SUBJECT: Coastside Design Review Continuance
Cedar Street, Montara
APN 036-132-210; County File No. PLN 2019-00362

At its meeting of October 14, 2021, the San Mateo County Coastside Design Review Committee (CDRC) considered your application for a Design Review Permit to allow a 2,450 sq. ft., 2-story, single-family residence with an attached two-car, 480 sq. ft. garage on a legal 6,975 sq. ft. undeveloped parcel (PLN 2016-00222), associated with a staff-level Resource Management (RM) Permit, Coastal Development Permit (CDP) and a Variance to allow for 10 foot front and side setbacks, and a 12 foot rear setback, where a 50 foot front yard setback and 20 foot rear and side yard setbacks are required, due to the triangular shape of the parcel. The project includes minor grading and the proposed removal of 10 significant trees. The project is not appealable to the California Coastal Commission. In light of concerns expressed by the neighbor to the south and as discussed at the meeting, the applicant will consult with Planning staff regarding the requested Variance(s) for front side and rear setbacks. CDRC has suggested that although the triangular shape of the parcel is challenging, t

SHEET C-2

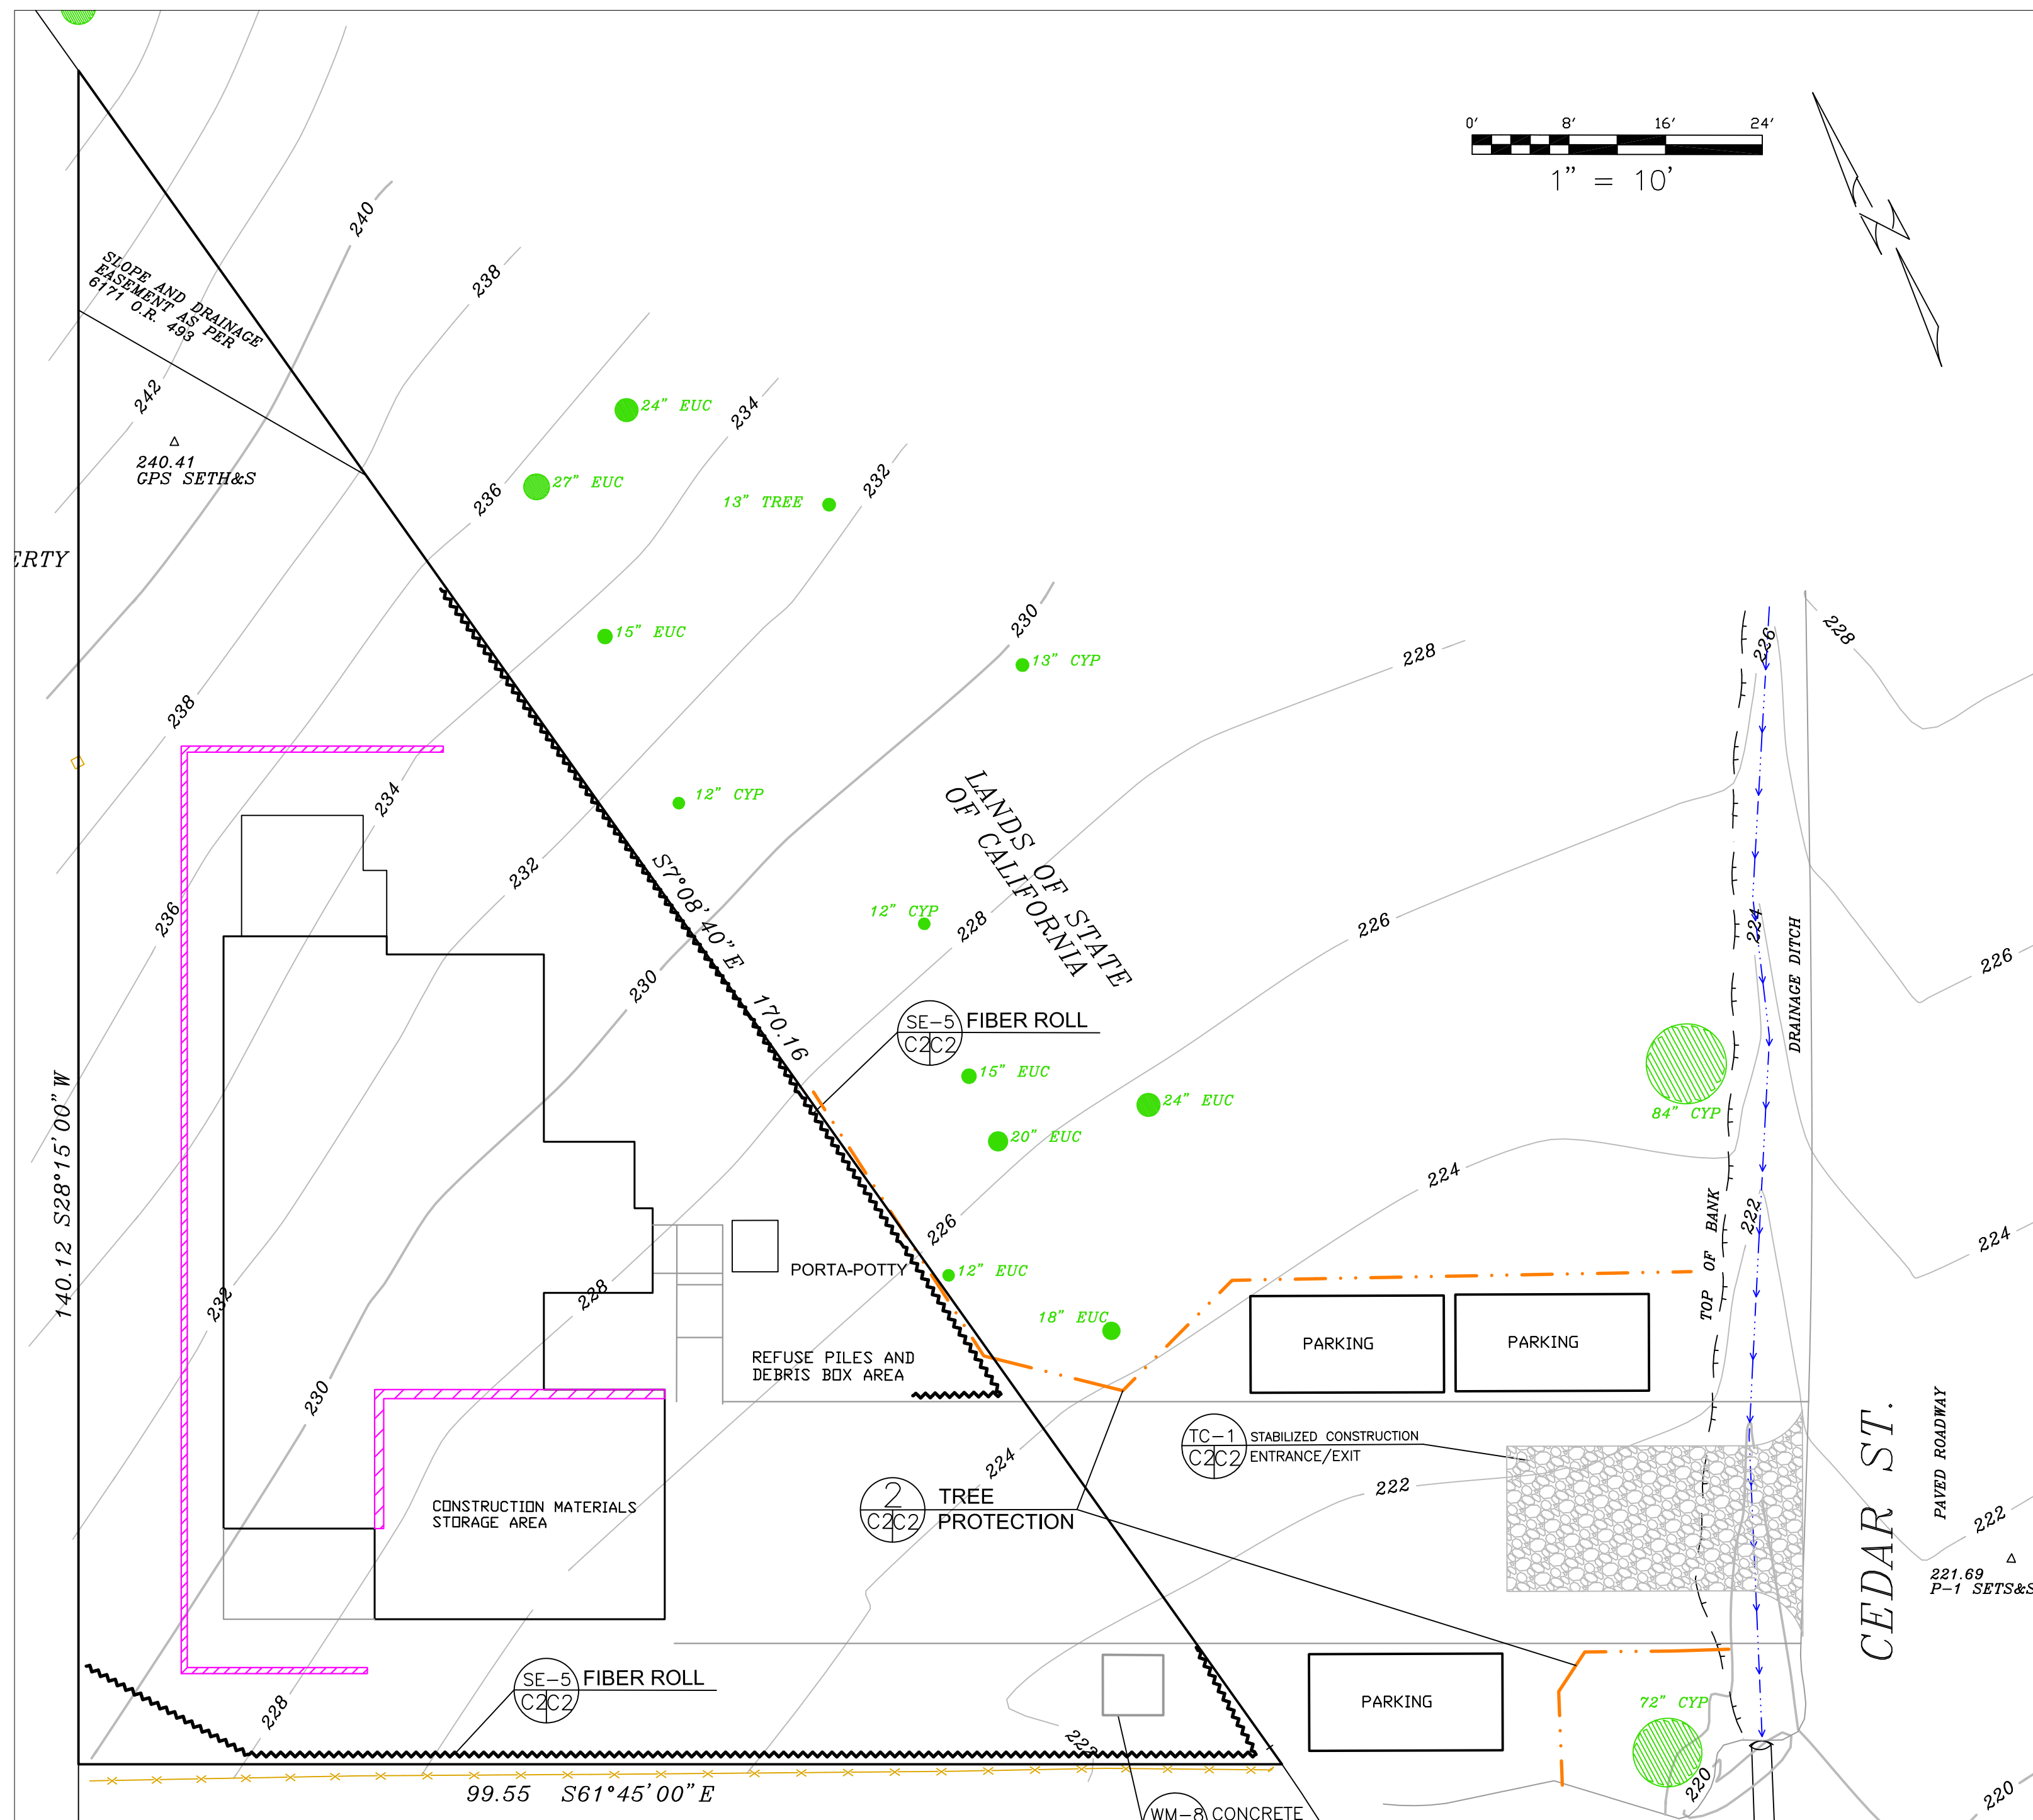
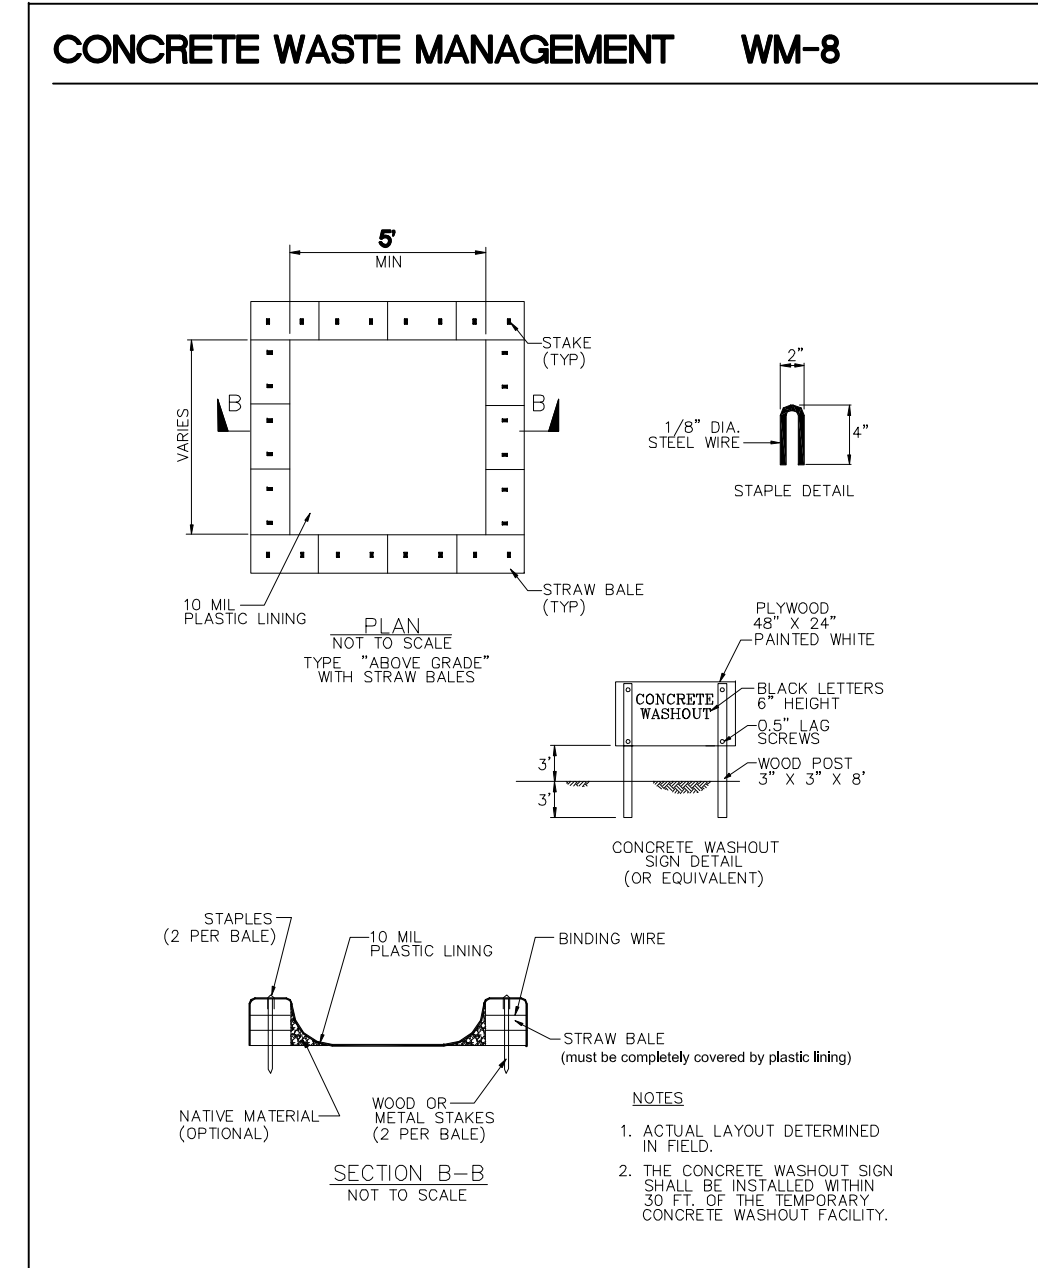
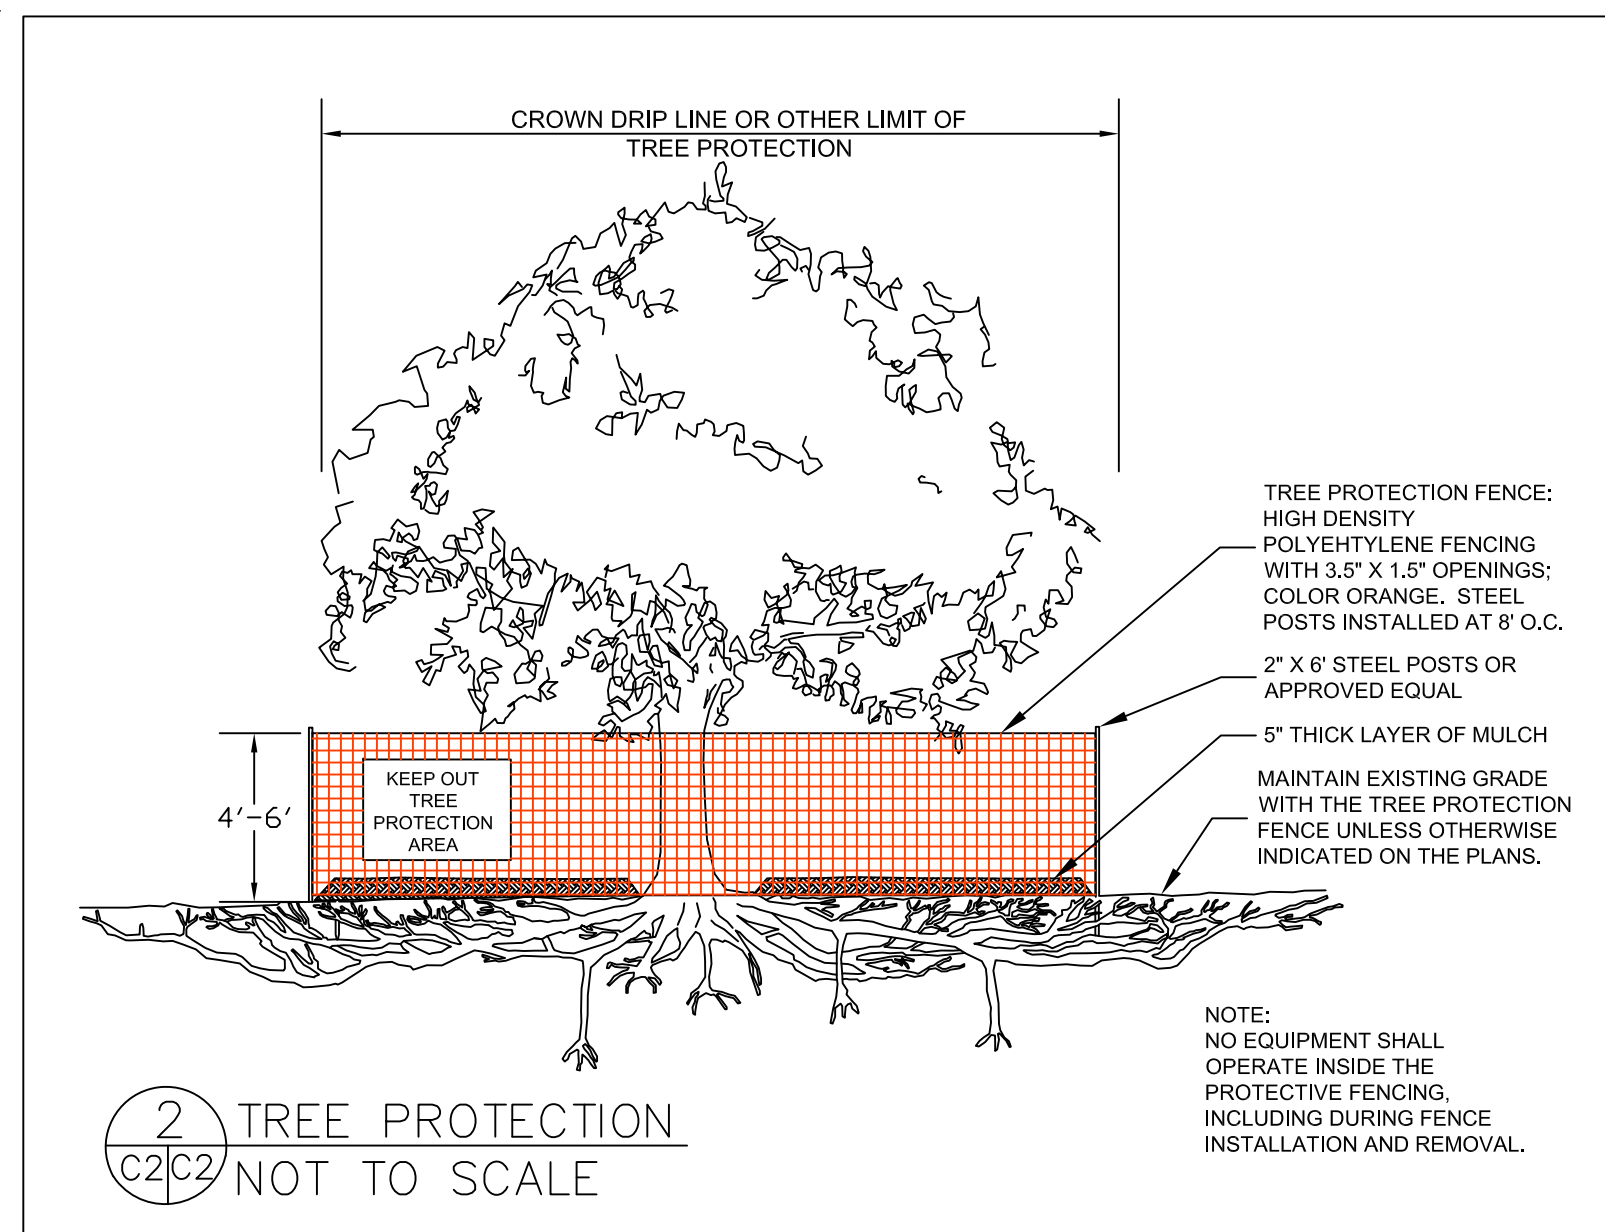
The proposed stabilized construction site entrance shows an excavation depth of 12 inches. The entrance is located 7 feet from large cypress tree #1, with a diameter of 72.6" and 24 feet from large cypress tree #2. Both cypress trees are very large mature trees. The construction site entrance requires an excavation depth of 12 inches. Because root growth is only in the top 3 feet of soil, with the majority of roots located in the top 18 inches of soil, the proposed excavation could potentially have a high impact on tree health and stability of cypress tree #1, as roots would need to be cut or damaged by aggregate compacted on top of the roots. It is recommended to have the construction site entrance on top of grade if possible. If excavation is needed, an excavation depth of 4 inches should be the maximum depth allowed when within 36 feet (6 times diameter) of Monterey cypress tree #1 and #2. Biaxial Geogrid is recommended to be used for the construction site entrance as this material can be pinned down over the existing soil as an underlayment which disperses loads laterally and helps to reduce compaction. Aggregate can then be placed on top of this material and will help to stabilize the soil.

The proposed parking areas when within 36 feet of cypress trees #1 and #2 must be on top of a landscape barrier to reduce risk of soil compaction within the root zone of cypress trees #1 and #2. Soil compaction is the leading cause of tree decline on construction sites as roots will die when soil is heavily compacted. Landscape barriers for vehicles shall consist of thick coarse

The proposed sewer line is 18 feet from cypress tree #1. This line is recommended to be excavated with the use of an air spade (air knife) in combination with hand tools when within 36 feet (6 times diameter) of cypress tree #1. All existing roots encountered within the trench must be exposed and remain as damage free as possible. The line must be tunneled underneath or between roots when possible. Root cutting shall stay as minimal as possible. The Project Arborist must be on site when excavation within 18 feet of this tree is to take place in order to document and inspect the work.

No roots shall be cut when within 18 feet (3 times diameter) of Monterey cypress tree #1 and #2 as these roots are critical for tree stability. The proposed driveway is located 7 feet from mature cypress tree #1 and 24 feet from cypress tree #2. It is recommended to construct the new driveway using biaxial geogrid (Tensar brand BX-1100) when within 36 feet (6 times diameter) of cypress tree #1 and #2. This geogrid can be pinned down over the existing soil surface as an underlayment which disperses loads laterally, and allows for building up a base section over the soil as a zero cut type driveway build. This will raise finished driveway grade elevation, but will also allow for thinning of the required base section thickness to as much as 50% below standard. Some initial grading will likely be needed to make a flat surface. Grading shall stay as minimal as possible. The maximum depth of excavation for the driveway allowed when within 18 feet from cypress tree #1 and #2 should be no greater than 4 inches. The Project Arborist must be on site to witness the construction of the driveway when within 36 feet of the cypress trees. Minor irrigation will be needed during the construction of the driveway. The top foot of soil shall be saturated in areas where no driveway will be located every 2 weeks during the construction of the driveway. Any roots to be exposed and retained or root ends that have been cut, must be wrapped in burlap and kept moist by keeping the burlap moist. If the above recommendations are followed, impacts to the trees are expected to be minor with no long term impacts.
